SACRAMENTO MUNICIPAL UTILITY DISTRICT 6201 S Street, P.O. Box 15830, Sacramento CA 95852-1830, (916) 452-3211  
RJR-85-424 AN ELECTRIC SYSTEM SERVING THE HEART OF CALIFORNIA

August 30, 1985

DOCKET 50-312  
RANCHO SECO NUCLEAR GENERATING STATION UNIT NUMBER 1  
SAFETY PARAMETER DISPLAY SYSTEM (SPDS) - REQUEST FOR ADDITIONAL  
INFORMATION DATED JULY 16, 1985

FIGURE 1  
RANCHO SECO CONTROL ROOM LAYOUT

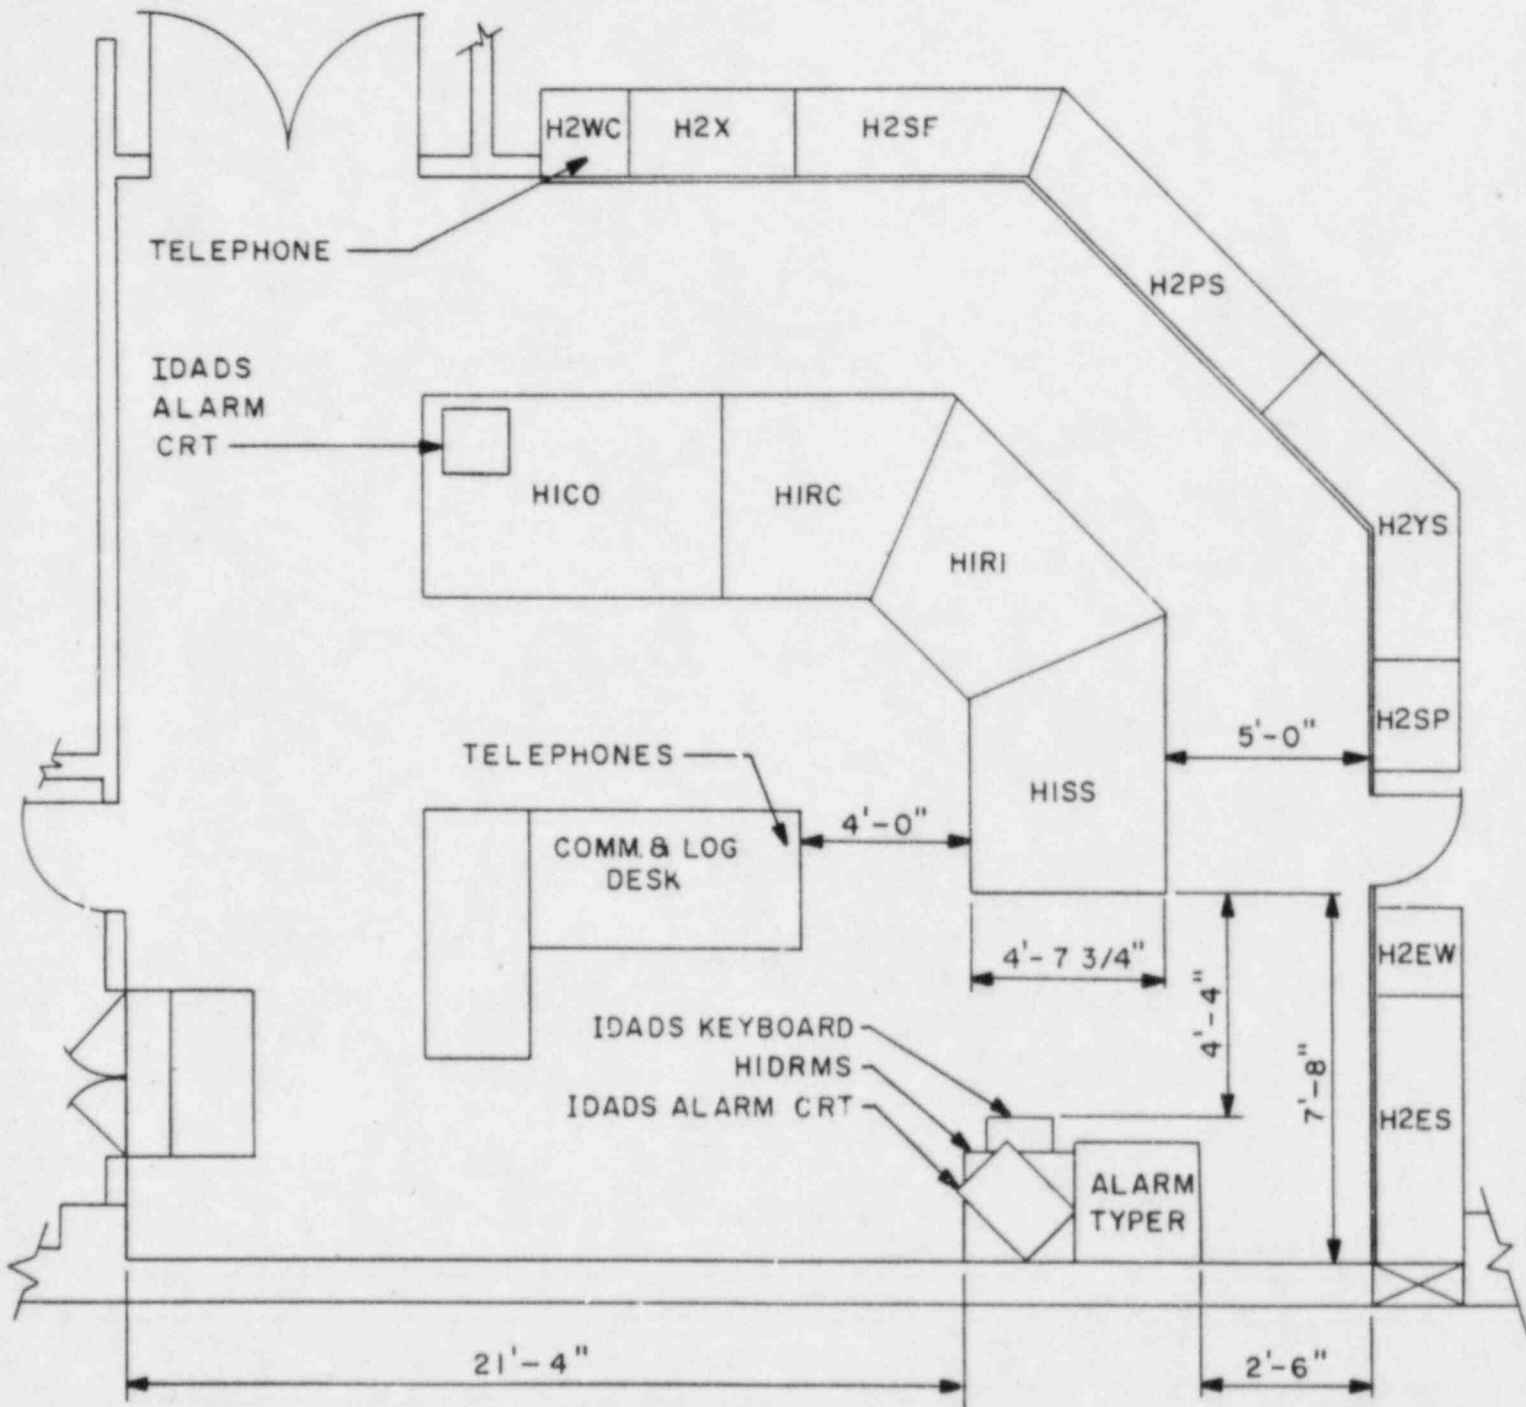
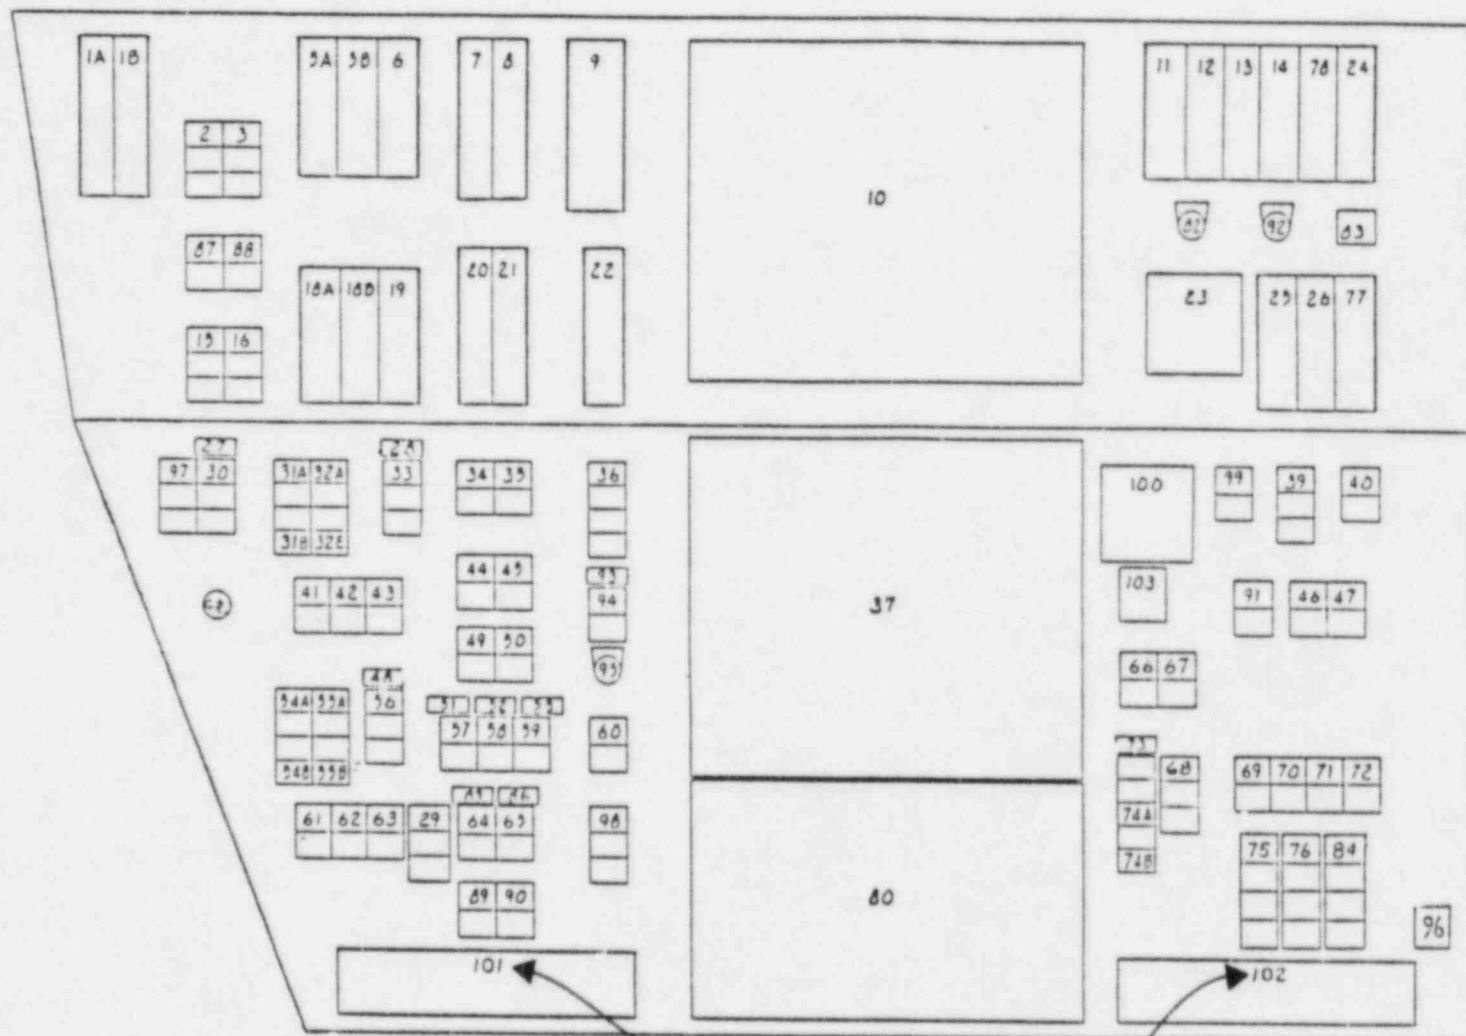
The Rancho Seco Control Room consists of backpanels, front consoles and miscellaneous operator aides. Miscellaneous operator aides include the operator communications and log desk, Digital Radiation Monitoring System (H1DRMS), and the Interim Data Acquisition and Display System (IDADS). The Control Room layout, Figure 1, shows the distances between the various panels and consoles. Additionally, layout drawings of H1SS for the SPDS controls (Figure 2, items 101 and 102), H2SP for the SPDS CRTs (Figure 3 items 1 and 2) have been included for your information. The control room is in the process of design review which may modify the layout of these panels.

FIGURE 5  
POST TRIP DISPLAY

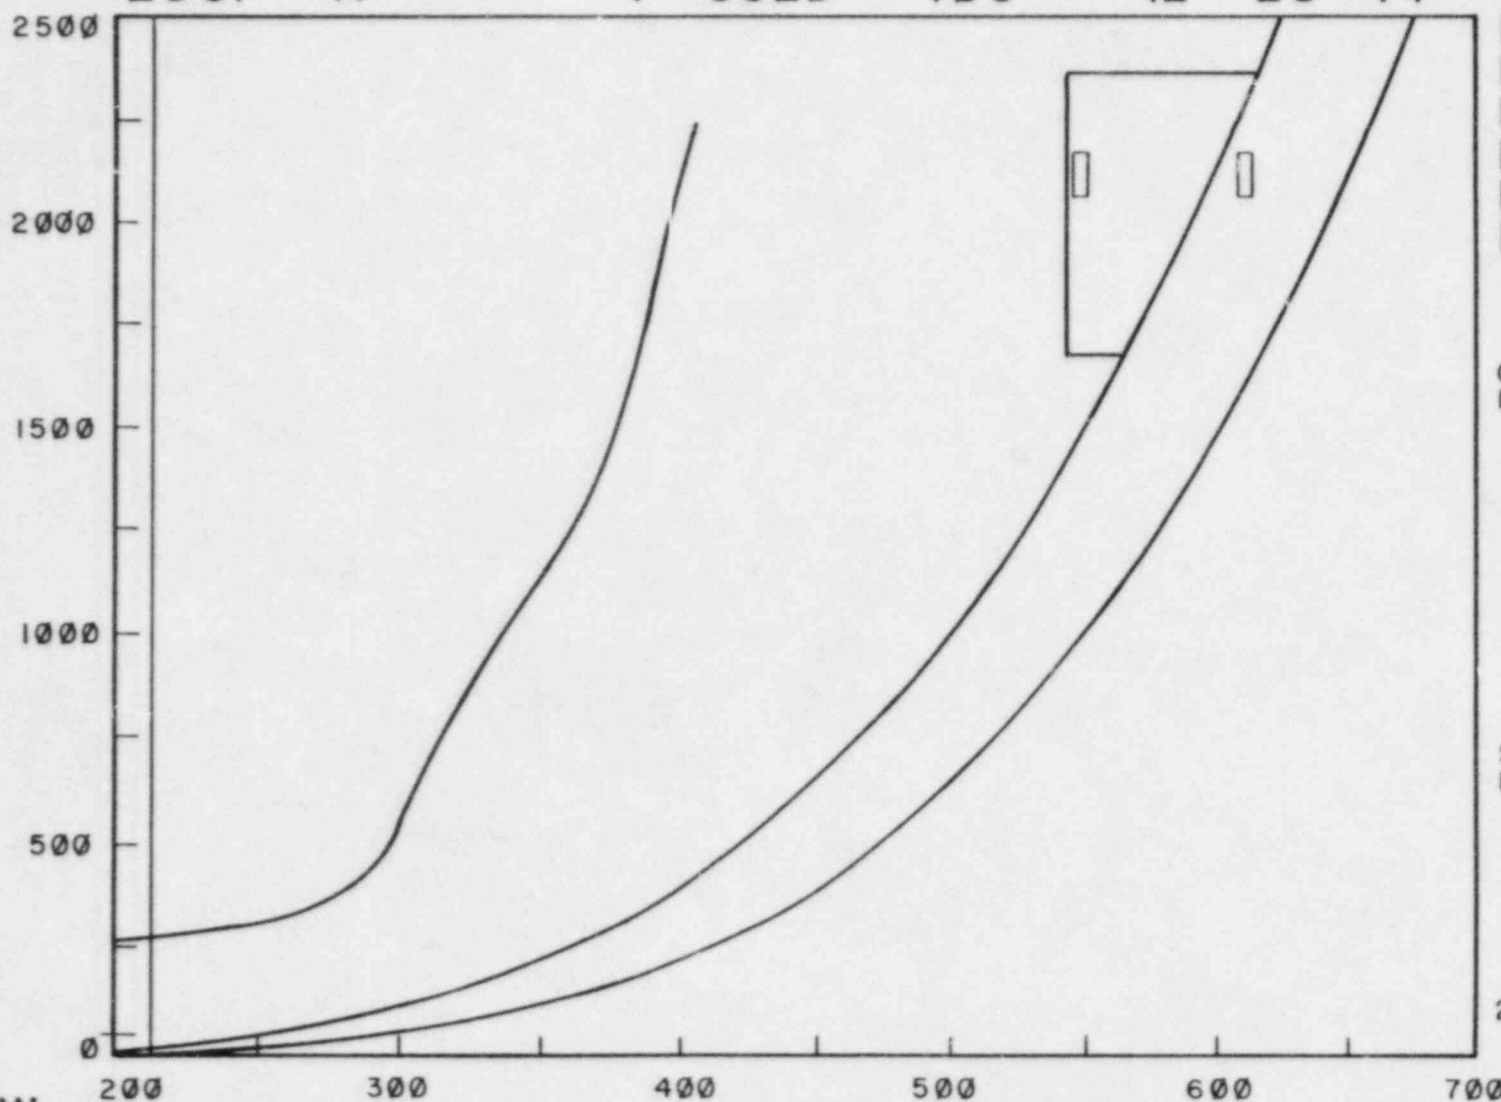
As described in the SMUD Safety Parameter Display Functional Description, B&W Drawing No., 1134042, Revision A-3, Section 2.2.15, "when a reactor trip occurs, the display shall switch to the post-trip ATOG display with history trace initialized". The SPDS CRTs thus automatically show the display format with the critical safety functions. No operator action is required to obtain this format (Figure 5). The critical safety functions and variables for each on this display are shown in Figure 6.

FIGURE 7  
SPDS CONTROL PANEL

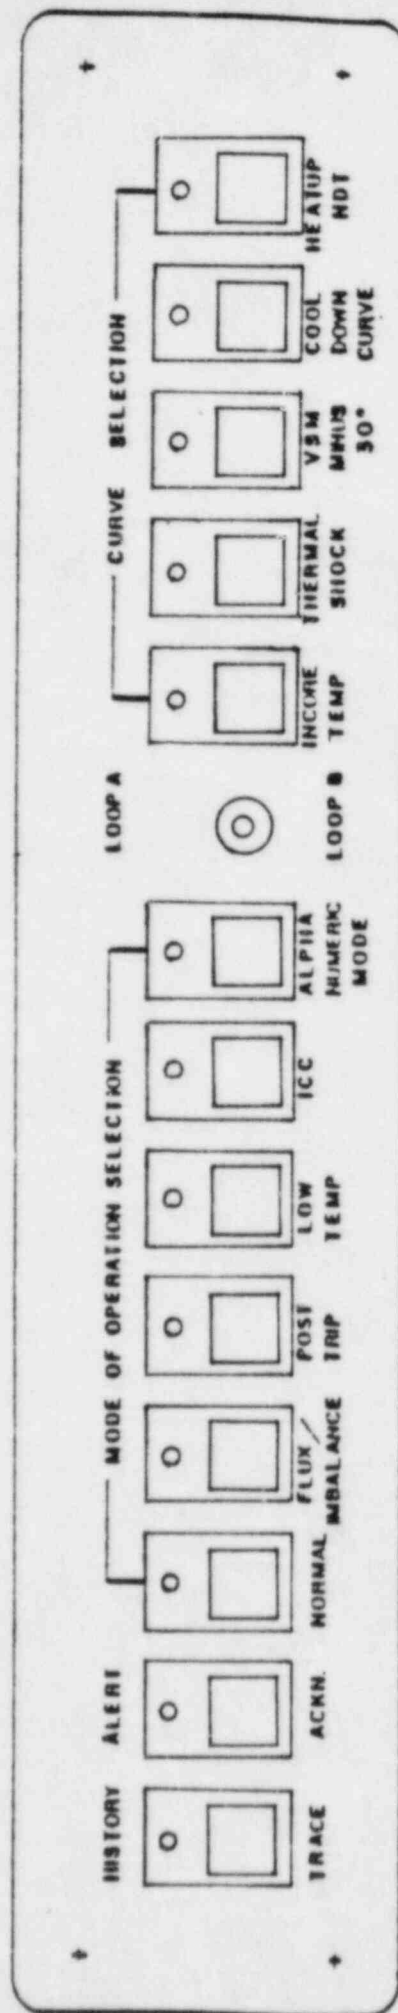
The SPDS provides additional displays for normal operations and inadequate core cooling. These displays enhance the operators familiarity with the SPDS. Display selection is by rocker switch with red LED indicating that the switch has been actuated (See Figure 7). Many of the critical safety functions are duplicated on the additional displays but only the post-trip display is necessary to see all of the critical safety functions addressed by the SPDS.
